APPLICATION NO.	FILING DATE	FIRST NAMED INVENTOR	ATTORNEY DOCKET NO.	CONFIRMATION NO.
10/807,000	03/23/2004	Ki-Chul Kim	5649-1266	2826
20792	7590	06/29/2005	EXAMINER	
MYERS BIGEL SIBLEY & SAJOVEC			NGUYEN, THINH T	
PO BOX 37428			ART UNIT	
RALEIGH, NC 27627			PAPER NUMBER	
			2818

Office Action Summary	Application No. 10/807,000	Applicant(s) KIM ET AL.	
	Examiner Thinh T. Nguyen	Art Unit 2818

DETAILED OFFICE ACTION

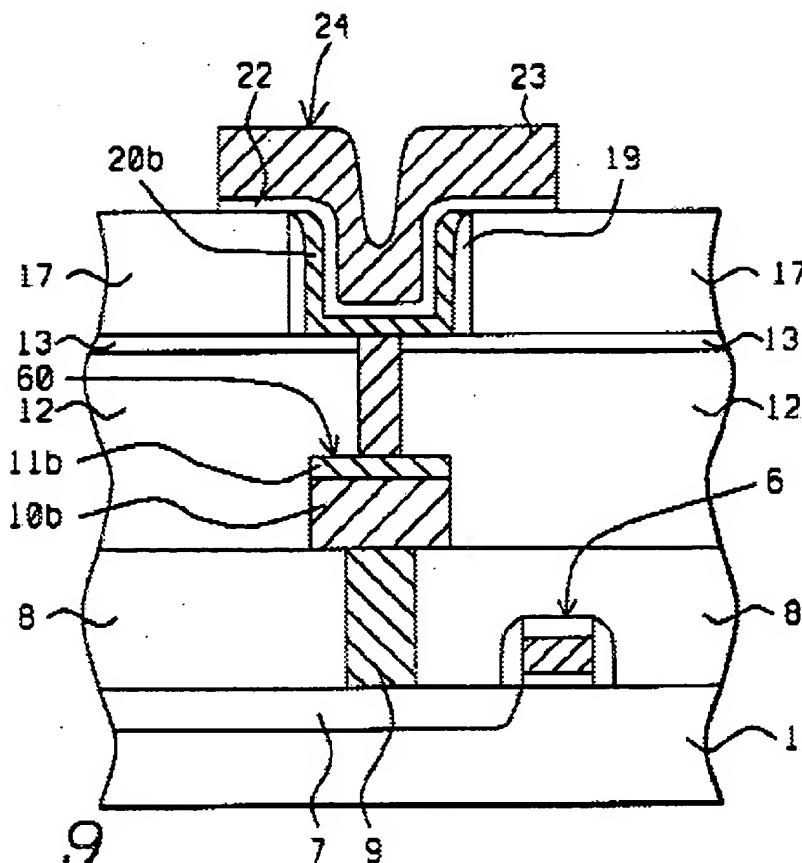
Lou (fig 9 ,column 4 line 21-22) discloses an integrated circuit comprising: a microelectronic substrate; a dielectric layer on the substrate; a conductive contact plug (fig 9 reference 9) extending through an opening in the dielectric layer to contact the substrate and including a widened pad (fig 9 reference 60) portion extending onto the dielectric layer adjacent the opening; an ohmic pattern on the pad portion of the plug; (fig 9 reference 10b) this layer is made of tungsten, a barrier pattern on the ohmic pattern (fig 9 reference 11b) made of ruthenium ; a concave first capacitor electrode disposed (fig 9 layer 20b) on the barrier pattern and defining a cavity opening away from the substrate; a capacitor dielectric layer (fig 9 layer 22) conforming to a surface of the first capacitor electrode; and a second capacitor electrode (fig 9 layer 23) disposed on the capacitor dielectric layer opposite the first capacitor electrode.

Lou (fig 9 ,column 4 line 21-22) discloses an integrated circuit device comprising: a microelectronic substrate; a dielectric layer on the substrate; a conductive contact plug extending (fig 9 reference 9) through an opening in the dielectric layer to contact the substrate and including a widened pad portion(fig 9 reference 60) extending onto the dielectric layer adjacent the opening; stacked ohmic (fig 9 reference 10b) and barrier patterns (fig 9 reference 11b) disposed on the pad portion of the plug and having sidewalls substantially coplanar with a sidewall of the pad portion; a first capacitor electrode (fig 9 layer 20b) disposed on the barrier pattern; a capacitor dielectric layer (fig 9 layer 22) on the first capacitor electrode; and a

FIG. 9

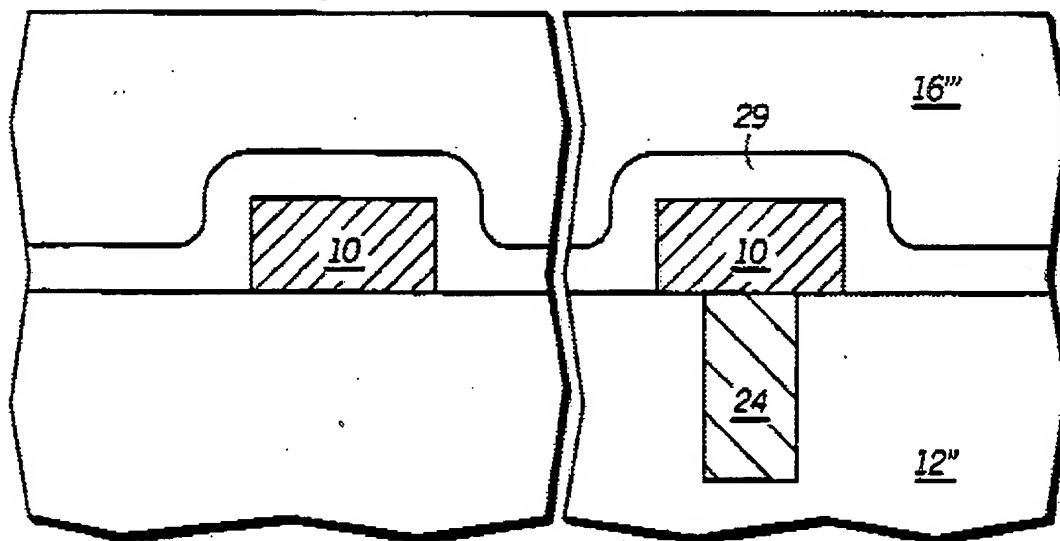
Lou discloses all the inventions of claims 3-6,14-17 except for the use of a conformal etch stop layer; this feature, however, is considered obvious since it is old and well known in the art (as shown by the disclosure by Woo et al. US patent 5,451,543 claim 4 and fig 9 conformal etch stop layer 29) a person skilled in the art at the time the invention was made would have been capable from using the teachings by Lou and his ordinary design skill and come up with the invention of claims 3-6 without any special instructions.

FIG. 4

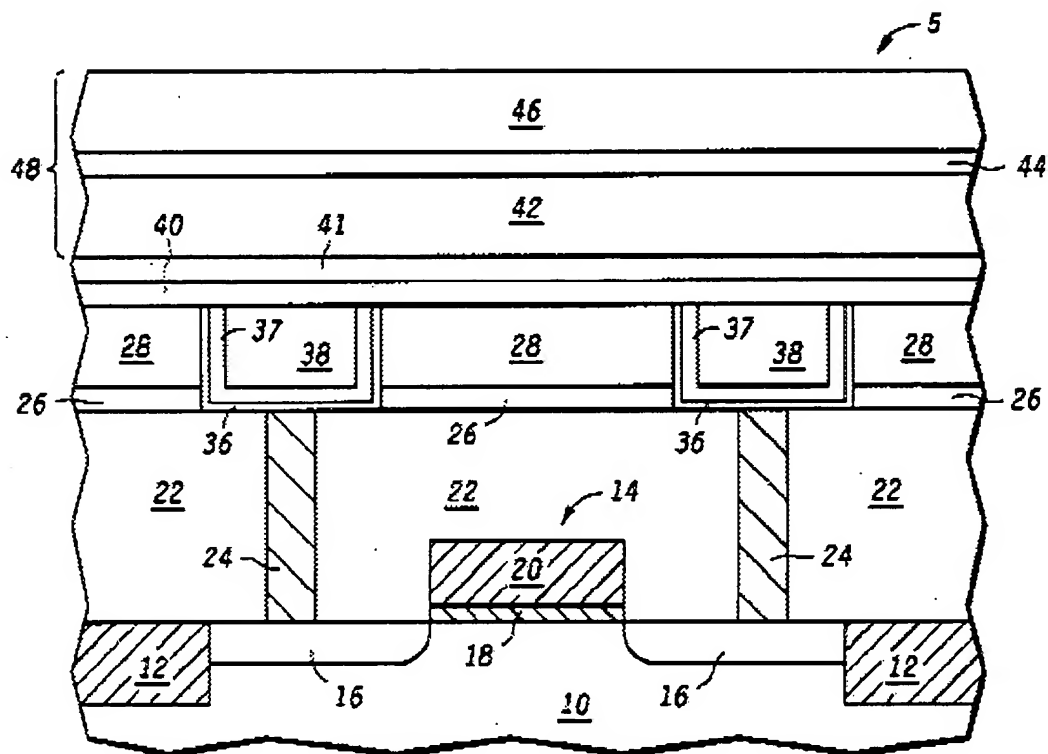
Lou discloses all the inventions except for the use of Titanium nitride, Tantalum nitride etc as barrier layer; this feature, however, is considered obvious since the use of titanium nitride or tantalum nitride as barrier layer are old and well known in the art as shown in the disclosure by Islam et al. (US patent 6,174,810), fig 4 barrier layer 36.

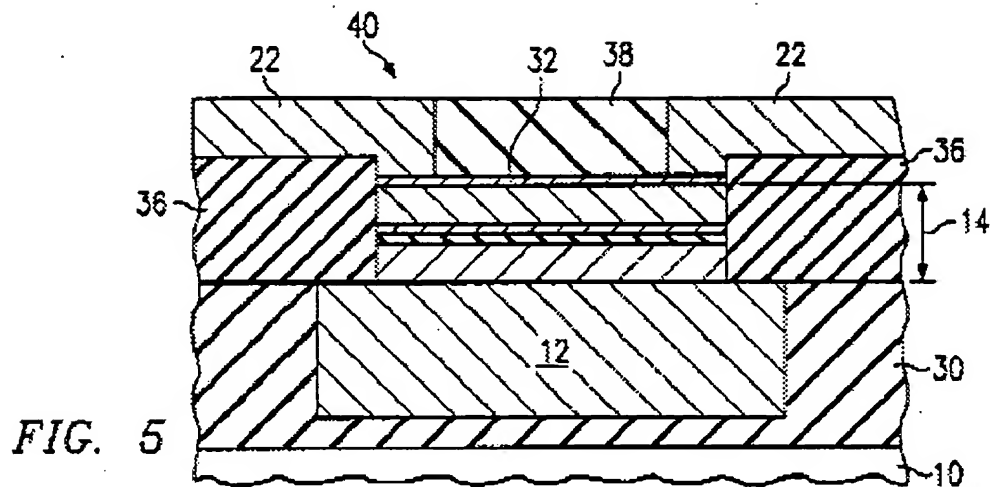
Lou discloses all the invention except for the use of a metal etches stopper layer. Luescher, however, discloses (fig 5 layer 32) the use of a metal etches stopper layer (column 6 line 30-34).
